APPEAL SUMMARY

| Appeal ID: 14942 | Project Address: 7202 NE Glisan St |
| Appeal Involves: Alteration of an existing structure, occ Change from F1 to B | LUR or Permit Application No.: 17-124289-CO |

| Code Section | OSSC 2014: Table 508.4 |

Floor Plan

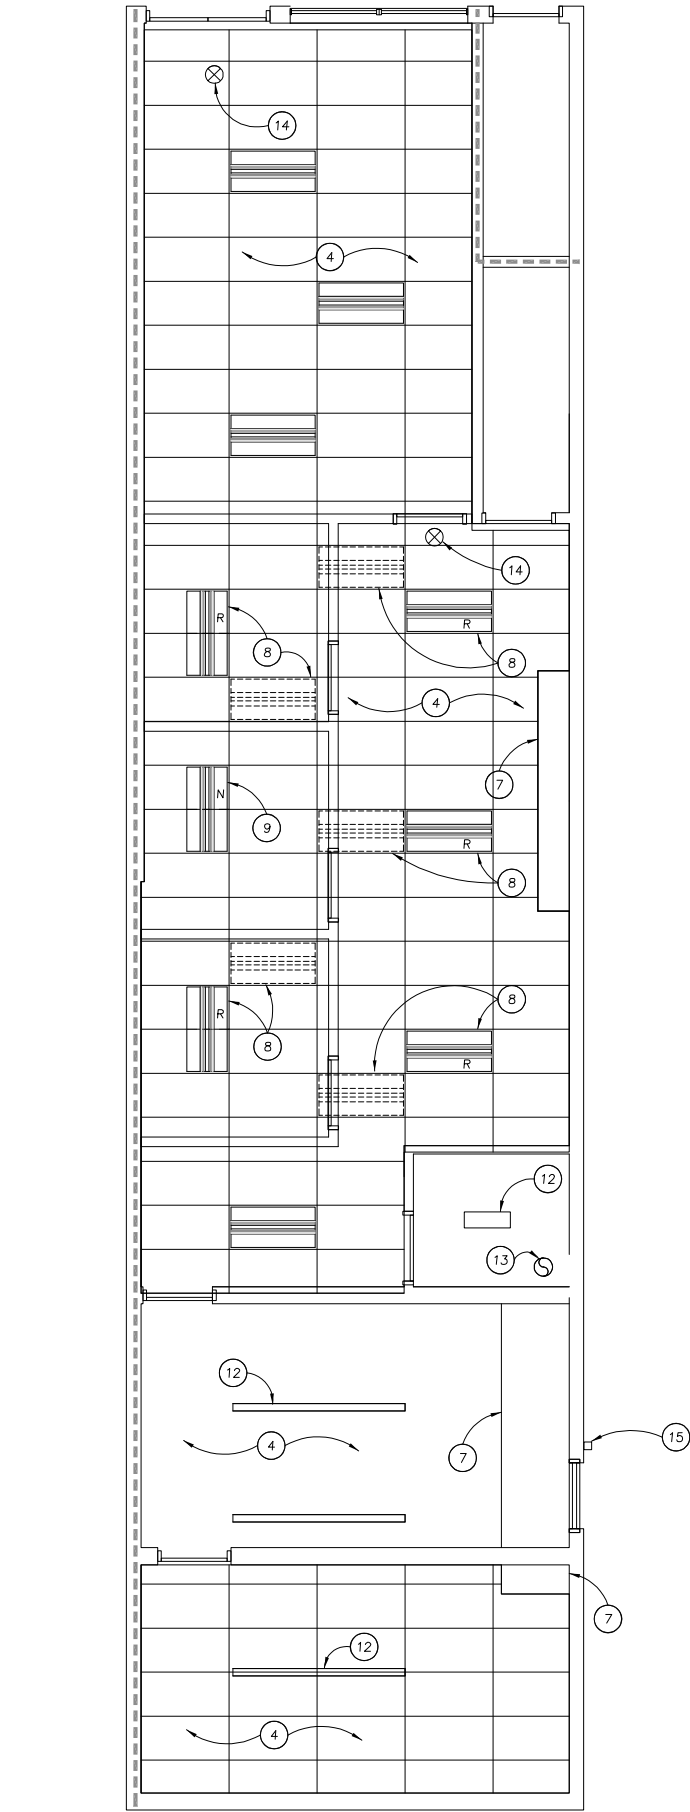
The proposed design includes the addition of three exam rooms to the existing approved space. These modifications do not impact the existing fire rated conditions; all demising walls and ceiling conditions will be maintained (see attached drawing sheets for reference).

During the design and code review, it was determined that the existing “rear” door – designated in the existing F1 space as an exit door – was not in compliance, nor was the exit pathway from this door to the right of way. Both the door and screen door lacked operable hardware, the exit door was equipped with a “key only” deadbolt lock. The exit pathway did not adequately provide the appropriate accessible walking surface or adequate clearances, nor does the gate (at the right of way) meet code to provide an accessible pathway. The proposed design addresses this noncomplying condition by utilizing Code Section 1014.3 for B occupancies with an occupant load of less than or equal to 30 – increasing the allowed travel distance to 100 feet and thereby using the main entry as the single exit allowable by code.

Alterations to the existing “rear” doors (both the door and screen door), providing appropriate hardware providing “free egress” at all times, and the addition of signage to this door indicating it as “NOT AN EXIT”.

Modification to the existing lighted exit signage, providing signs directing occupants to the main doors; and providing a door swing in the direction of exit travel for the new door within the travel pathway.

Providing additional fire extinguishers within the tenant space, limiting the travel distance to extinguishers from the required 75 feet to 25 feet.

Provide existing one hour occupancy separation between B and R3 above: Granted as proposed.

**Site Plan
7202 Glisan St.
Suite A/B**

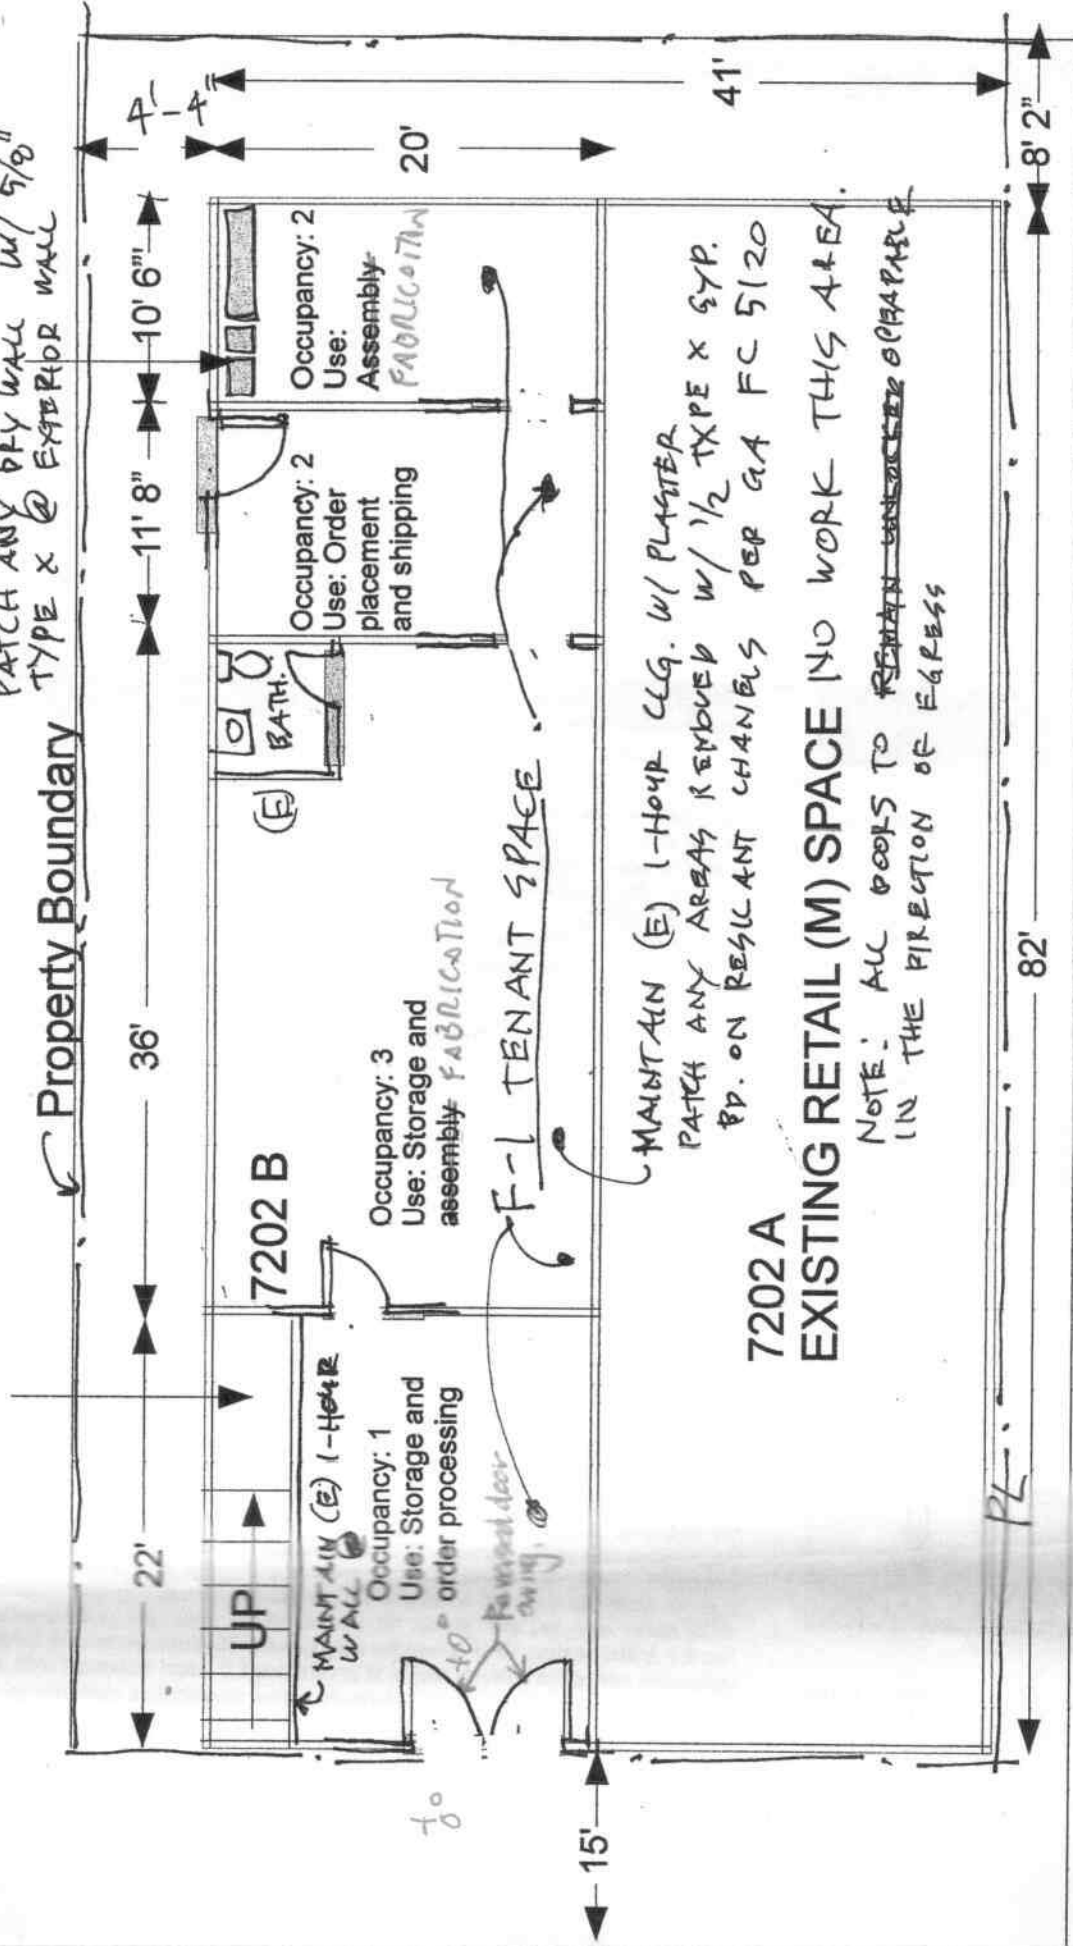
Maintain existing 1-HR ceiling, provide 1/2" type "X" gyp bd on resilient channels per CA TC 5/20 @ areas where plaster has been removed. ^{NEW}

Location of plumbing & dry wall work
PATCH ANY DRY WALL w/ 5/8"
TYPE X @ EXTERIOR WALL

5/14/15 Engelhardt: In addition to the previous comments in folder description the plans should show
 1) double lines for the walls.
 2) will need 2-hour occupancy separation between the new F-1 and R-3 (2 units) above. This could probably be appealed down to one-hour.
 3) provide site plan showing location of property lines
 4) label use of the various rooms
 5) if front of building is at the Glisan St property line, the doors are not to swing out, show that they will be fixed to swing in. Property line should be 15 feet in from curb according to city maps.
 6) show the area of sheetrock repair on the plans

One Hour Occupancy Separation Between F1 and R3 Occupancy Classifications: Granted as proposed.
This appeal is granted for this tenant and configuration only.

**Cross-Section
7202 Glisan St.
Suite B**

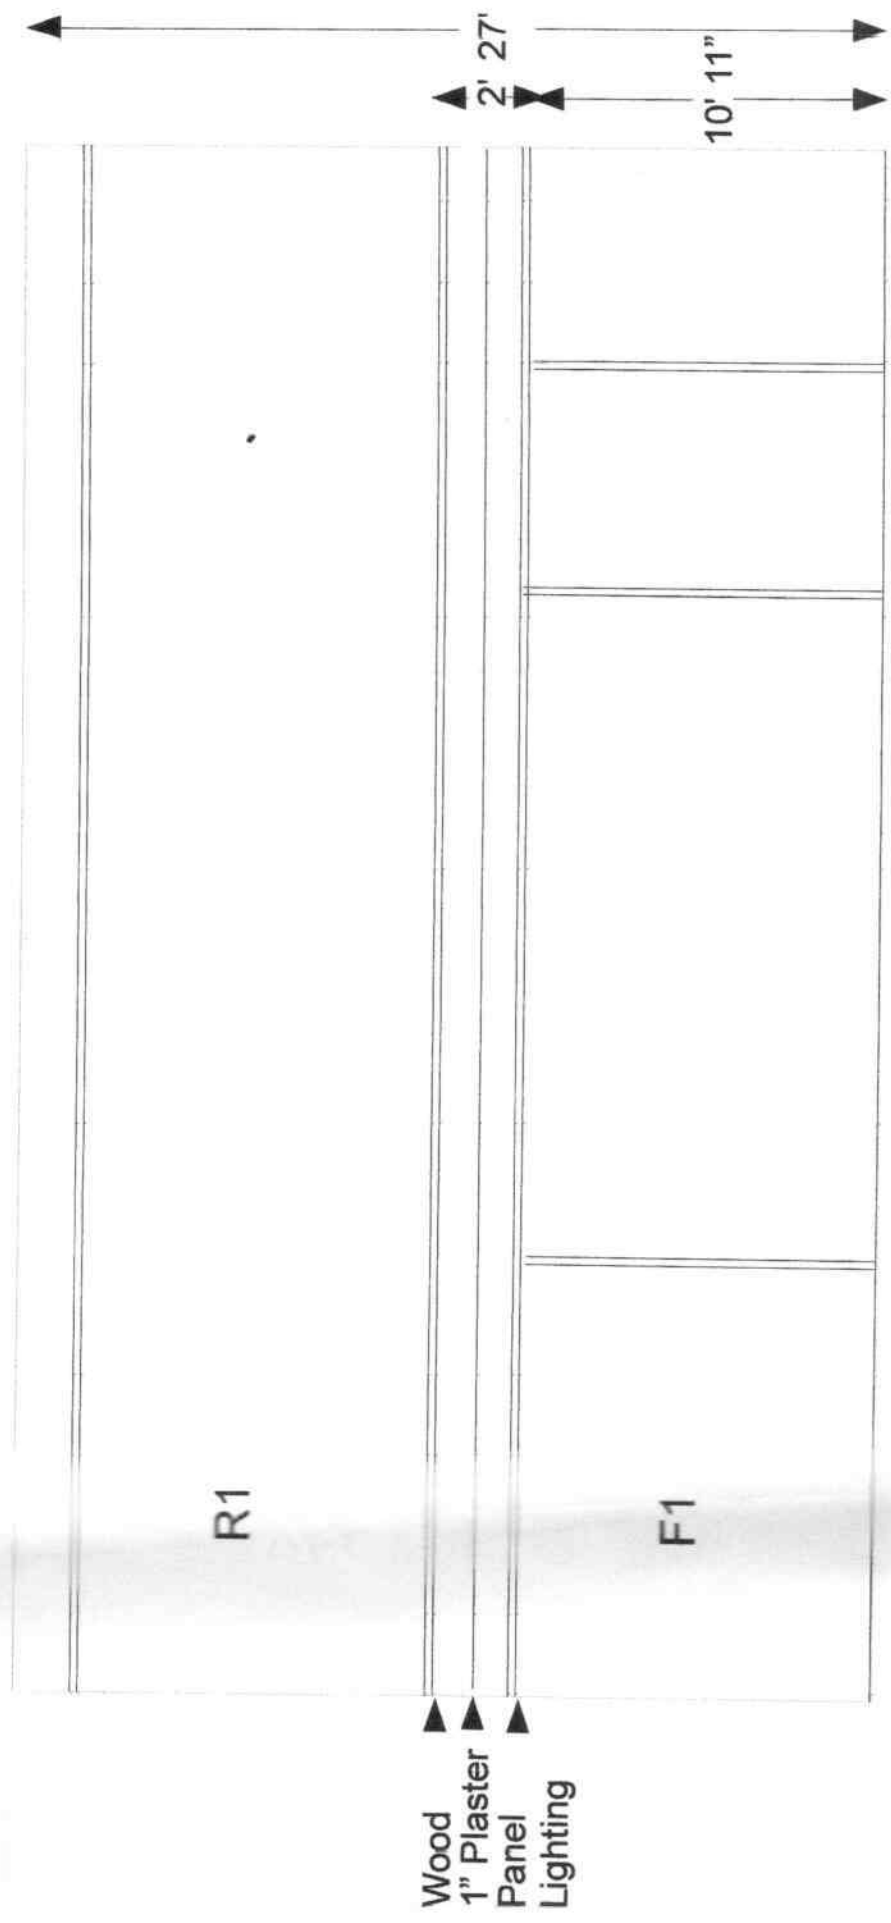
EXISTING CONDITIONS SHOWN ON SECTION. PROPOSED TO REMAIN, UNCHANGED, PER DISCUSSION W/ TERRY W. & JOHN C. ON 5/18/15. LESS OCCUPANTS AND NON-HAZARDOUS FABRICATION FOR RETAIL SHIPMENT.

| 2015 171323 000 00 CO | | <div> <p>A Text Field Editor (Maximum 4000 characters)</p> <p>5/18/15 JCooley: Applicant to appeal 2-hour fire rating at cig. prior to issuance. Plans noted with maintaining (E) plaster per T. Whitehill. Applicant to appeal opening close to property line OK to approve once appeals are granted.</p> </div> | | |
